From: [Glen Donaldson \(Place\)](#)
To: [Nick Brookman](#)
Cc: [Steven Gunn-Russell](#); [Planning Comments \(HPBC\)](#)
Subject: FW: Dinting Vale HPK/2022/0456 - Transport
Date: 18 July 2023 16:01:25
Attachments: [image003.png](#)

From: Glen Donaldson (Place)
Sent: 06 July 2023 15:43
To: planning@highpeak.gov.uk
Cc: Steven Gunn-Russell <Stevengr@whitepeakplanning.co.uk>
Subject: Dinting Vale HPK/2022/0456 - Transport

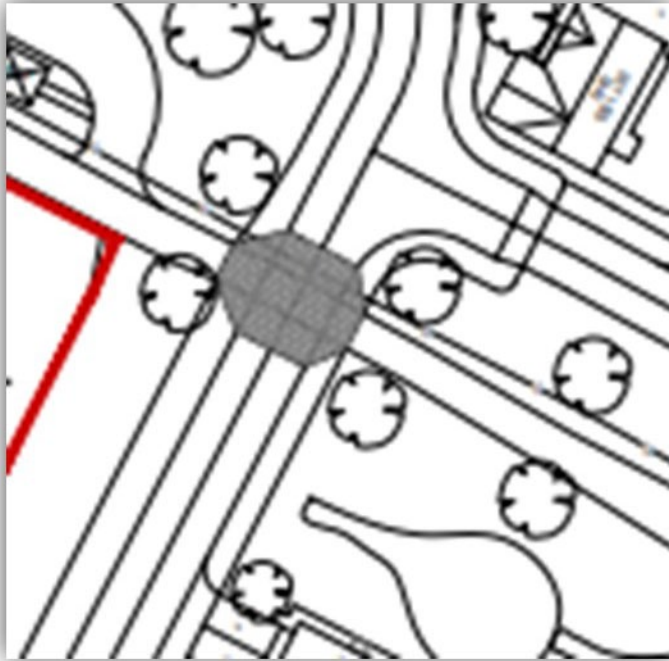
I am also aware of the requirements of the 'Inclusive Mobility' DfT 2022 which States:
'Generally, pedestrian environments should be level, which means that there should be no

gradient in excess of 1 in 60. Effort should be made to ensure that the route is smooth, since even small dips or gaps in paving points might present a hazard such as to people who use a stick or a crutch. If a level route is not feasible, then gradients should not exceed 1 in 20. (A slope steeper than this is generally defined as a 'ramp'). Even if a pedestrian route has no slopes in excess of 1 in 20, it is important that there are level sections, or 'landings', at regular intervals. This is to provide people with an opportunity to rest; where possible accessible seating should be provided on such landings. A level landing should be provided for every 500mm that the route rises. The length of each landing should be equal to at least the width of the ramp'

The County Council must be mindful of all highway users, so the levels must be reassessed and conform with the 1:20 requirement.
